Title of Change:	Update to FPCN22672Z - cancellation notice of leadframe design change for u8FL Wettable Flank (WF) package with inhouse electroplating process in ON Semiconductor Seremban, Malaysia.
Proposed Changed Material First Ship Date:	02 Dec 2019 or earlier if approved by customer
Current Material Last Order Date:	N/A
Current Material Last Delivery Date:	N/A
Product Category:	Active components – Discrete components
Contact information:	Contact your local ON Semiconductor Sales Office or Ammar.Anuar@onsemi.com
PCN Samples Contact:	Contact your local ON Semiconductor Sales Office to place sample order or <PCN.samples@onsemi.com>. Sample requests are to be submitted no later than 45 days after publication of this change notification. Samples delivery timing will be subject to request date, sample quantity and special customer packing/label requirements.
Sample Availability Date:	N/A
PPAP Availability Date:	N/A

Update to FPCN22672Z – This is a cancellation of the previously announce notice of leadframe design change for u8FL Wettable Flank (WF) package with inhouse electroplating process in ON Semiconductor Seremban, Malaysia.

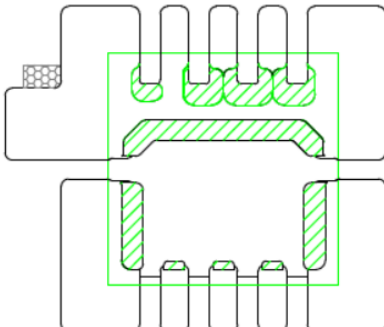
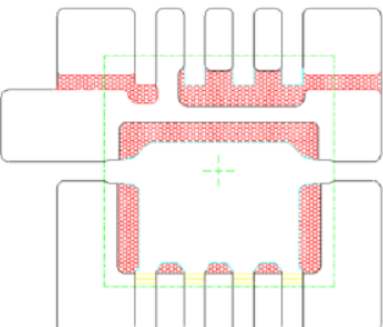
Before Change Description	After Change Description
Leadframe Supplier	MSHE (Malaysia)	Kang Qiang(China)
Leadframe Process	Stamp	Etch
	1. No tie bar connect to the gate and source lead	1.Additional tie bar connect to gate and source lead
Leadframe Design	2. Chamfer flag	2. Removed chamfer
	3. coining area-stamp LF	3. Half etched area.

Sidewall plating method	Electroless SN plating	Electrolytic SN plating
Wettable Plating Site	Metek (Sub-con)	Seremban (Inhouse)

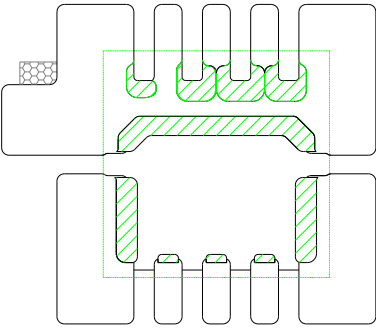
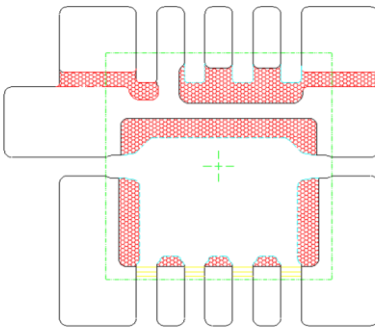
変更カテゴリ:	変更種別	
装置	異なる基本技術を用いた新しい装置/ツール、またはその独特な形状や機能により最終製品の完全性に影響を与えることが見込まれる新しい装置/ツールでの生産	
プロセス – 組立	プロセステクノロジー (ダイアタッチ、ボンディング、成型、めっき、トリム & フォーム、フレーム準備等...)の変更 直材サプライヤの変更 指定のアセンブリプロセス順序の変更(プロセス手順の追加または削除) 組立のすべてまたは一部の異なる場所 / 拠点 / 外注への移管 (追加製造拠点の認定)	
説明および目的:		
FPCN22672Z の更新 – これは先にアナウンスしました、オン セレンバン(マレーシア)における自社内電解めっきプロセスの u8FL ウェットابل・フランク(WF) パッケージのリードフレーム設計変更をキャンセルするものです。		
FPCN22672Z – 車載用MOSFET製品の自社内電解めっきプロセスを採用したダミータイバーアプローチ使用のu8FLウェットابل・フランク(WF)		
変更される材料	変更前の表記	変更後の表記
リードフレームサプライヤー	MSHE (Malaysia)	Kang Qiang(China)
リードフレームプロセス	スタンピング	エッチング
リードフレーム設計	1. タイバーがゲートとソースリードに接続されていない 2. 面取りフラグ 3. コイニングエリア - スタンプ LF	1.追加のタイバーがゲートとソースリードに接続されている 2.面取りなし 3.半分のみエッチング

側面のめっき方法	無電解 SN めっき	電解 SN めっき
ウェットブルめっきサイト	Metek (外注)	Seremban (自社)
